Form 3160-5 (June 2019)

1. Type of Well			0. W. II.N. 1.N.	
Oil Well Gas W	_		8. Well Name and No	ROSS DRAW 17 FED COM/708H
2. Name of Operator EOG RESOURC	CES INCORPORATED		9. API Well No. 30-0	015-47725
3a. Address 1111 BAGBY SKY LOB	BY 2, HOUSTON, TX 77(3b. Phone No. (713) 651-70		10. Field and Pool or PURPLE SAGE; \	Exploratory Area WOLFCAMP (GAS)

Revised Permit Information 06/08/2022:

2587' FNL 2548' FWL **Revised Wellbore**

Eddy County, NM (NAD 83 NME) Ross Draw 17 Fed Com Plan #0.2

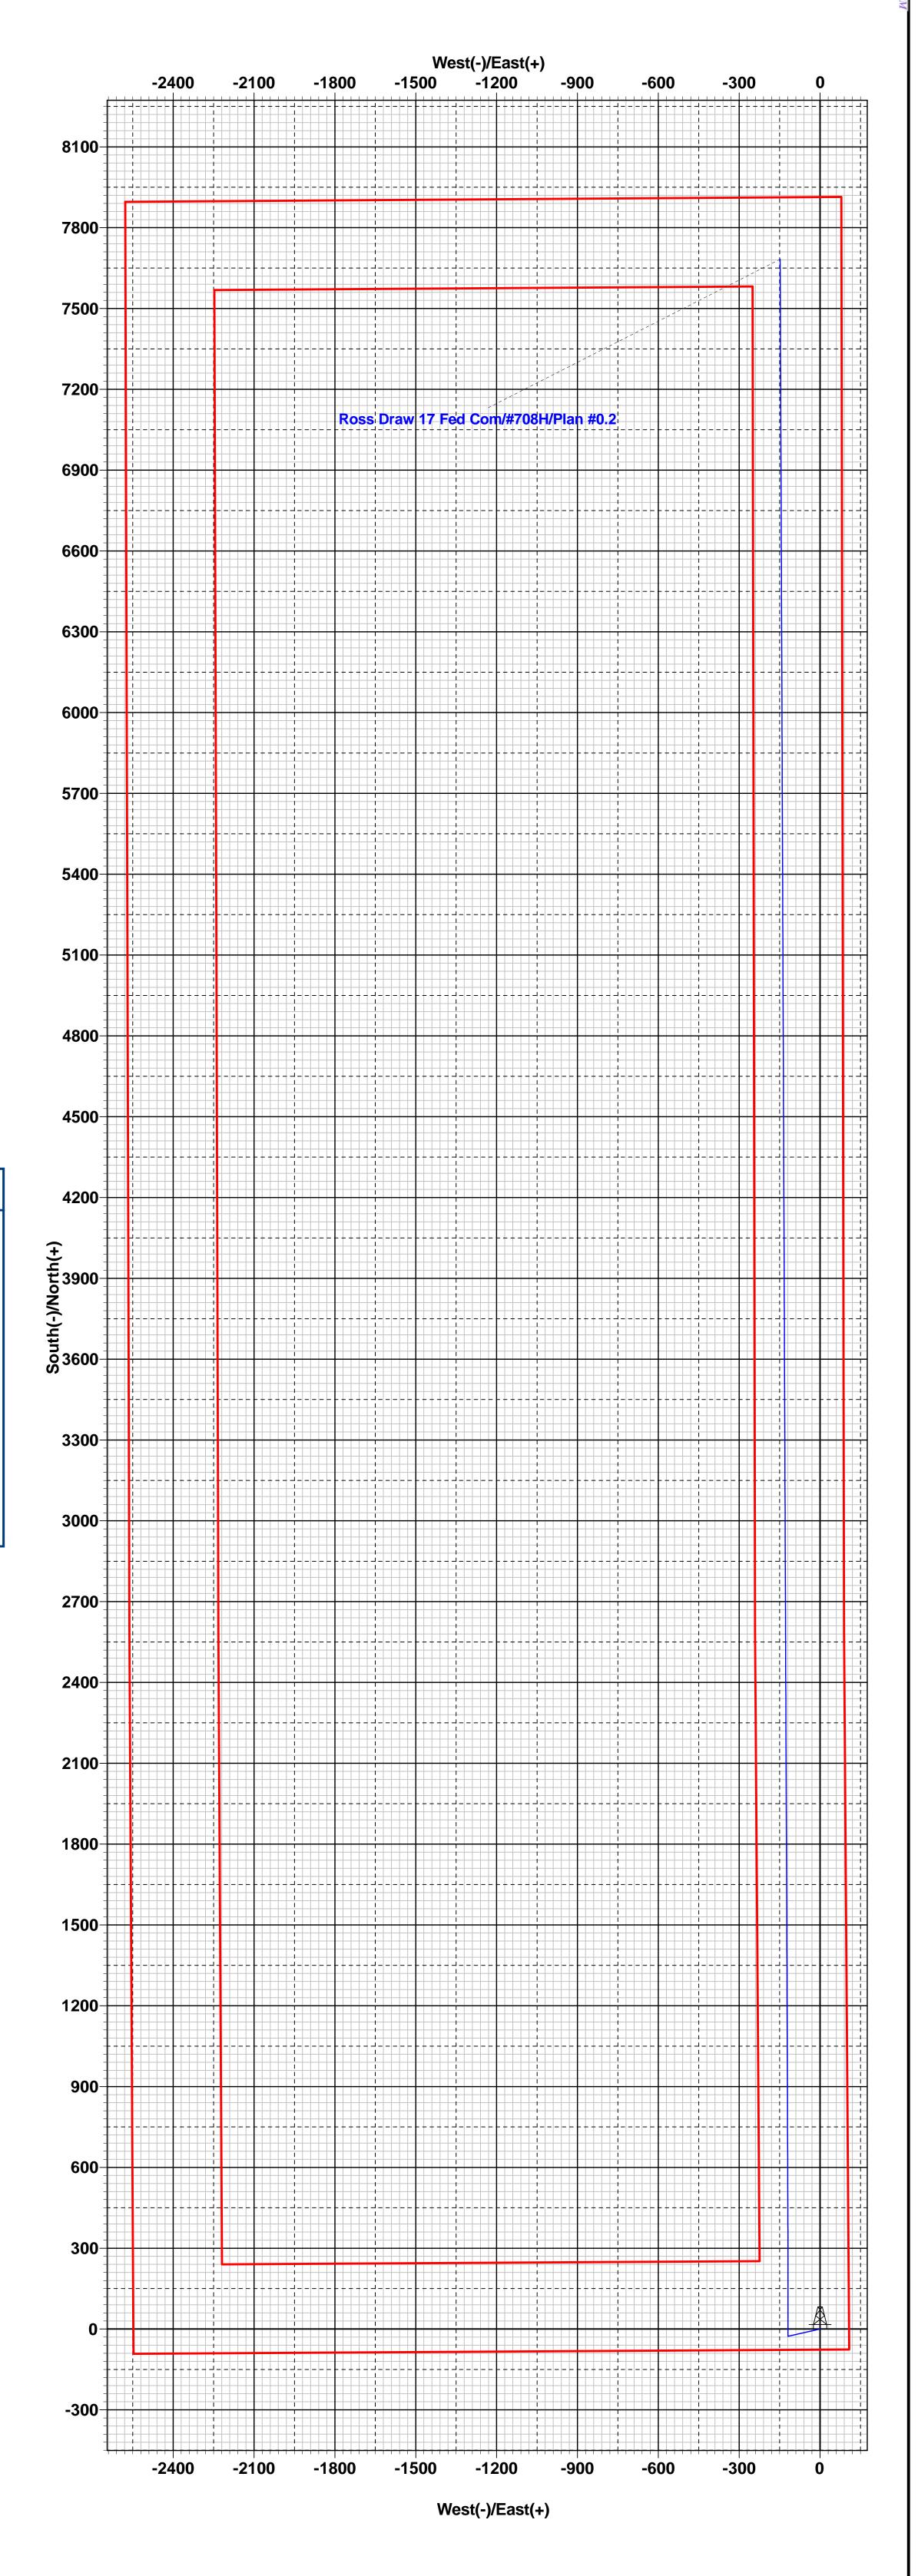
Location: SHL: 2587' FNL & 2548' FWL, Section 17, T-26-S, R-31-E, Eddy Co., N.M.

BHL: 230' FNL & 2430' FWL, Section 8, T-26-S, R-31-E, Eddy Co., N.M.
